DART AEROSPACE LTD	Work Order: 78700
Description: Crosstube High Fwd (205/212/412)	Part Number: D212-664-101
Inspection Dwg: D212-664-141 Rev: D	Page 1 of 1

DART AEROSPACE LTD HAWKESBURY, ONTARIO, CANADA	
DRAWING NO. D212-664-141	REV. D SHEET 1 OF 4
TITLE XTUBE ASS'Y (205/212/412 HI FWD)	SCALE NTS
COPYRIGHT © 2000 BY DART AEROSPACE LTD. THIS DOCUMENT IS PRIVATE AND CONFIDENTIAL, AND IS SUPPLIED ON THE EXPRESS CONDITION THAT IT IS NOT TO BE USED FOR ANY PURPOSE OR COPIED OR COMMUNICATED TO ANY OTHER PERSON WITHOUT WRITTEN PERMISSION FROM DART AEROSPACE LTD.

DRAWING NO. D212-664-141	TITLE XTUBE ASSY (205/212/412 HI FWD)	REV. D	DART AEROSPACE LTD ENGINEERING ORDER		D.E.O. NO. D212-664-141-D-1	SHEET NO. SHEET 1 OF 2	SCALE NTS
DRAWN	CHECKED <i>UP</i>	MFG. APPR. <i>ER</i>	APPROVED <i>MP</i>	DE APPR. <i>MP</i>			
DATE 11.04.07	DATE 11.07.11	DATE 11.04.12	DATE 11/04/12	DATE 11.04.12

DRAWING NO. D212-664-141	TITLE CROSSTUBE ASS'Y (205 HI FWD)	REV. D	DART AEROSPACE LTD ENGINEERING ORDER		D.E.O. NO. D212-664-141-D-2	SHEET NO. SHEET 1 OF 1	SCALE NTS
DRAWN <i>UP</i>	CHECKED <i>AS</i>	MFG. APPR. <i>AB</i>	APPROVED <i>MD</i>		DE APPR. <i>HH</i>		
DATE 11.07.15	DATE 11.07.20	DATE 11.07.21	DATE

**D212-664-141/-141B
ASSEMBLY DETAIL**

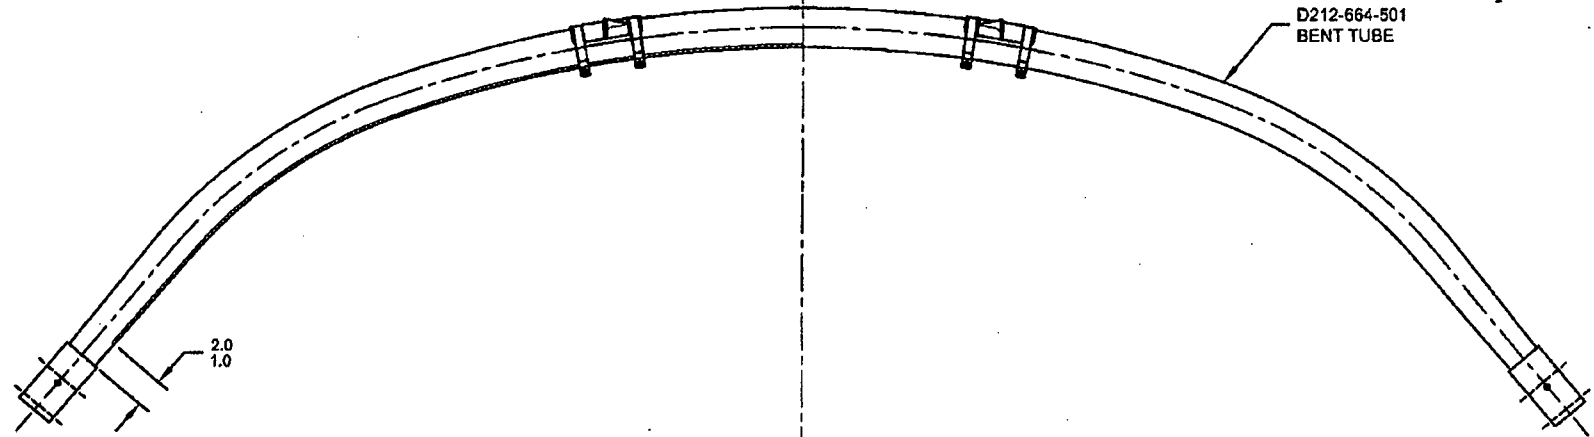
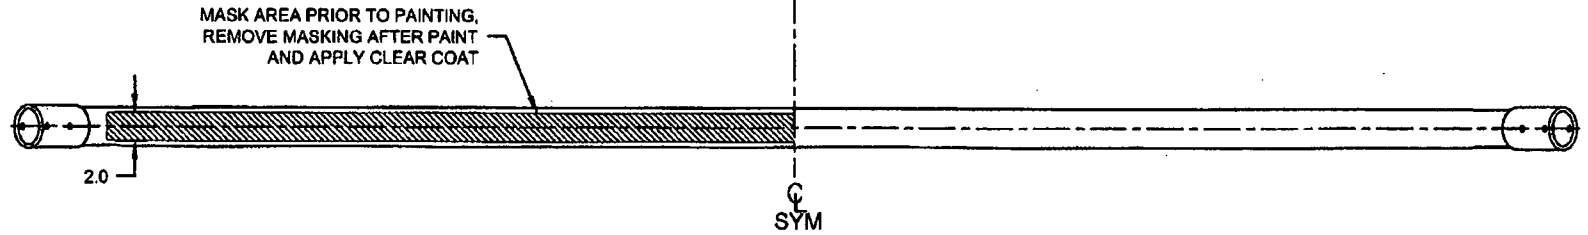
ADD AN INSPECTION WINDOW TO UNDERSIDE OF CROSSTUBE.

NOTES 2 OF SHEET 1 IS AMENDED AS FOLLOWS:

- 2) FINISH: CHEMICAL CONVERSION COAT PER DART QSI 005 4.1
PRIME INSIDE AND OUTSIDE PER DART QSI 005 4.2
MASK UNDERSIDE OF CROSSTUBE AS SHOWN (HATCHED AREA) AND
PAINT OUTSIDE PER DART QSI 005 4.2
REMOVE MASKING AND APPLY CLEAR COAT
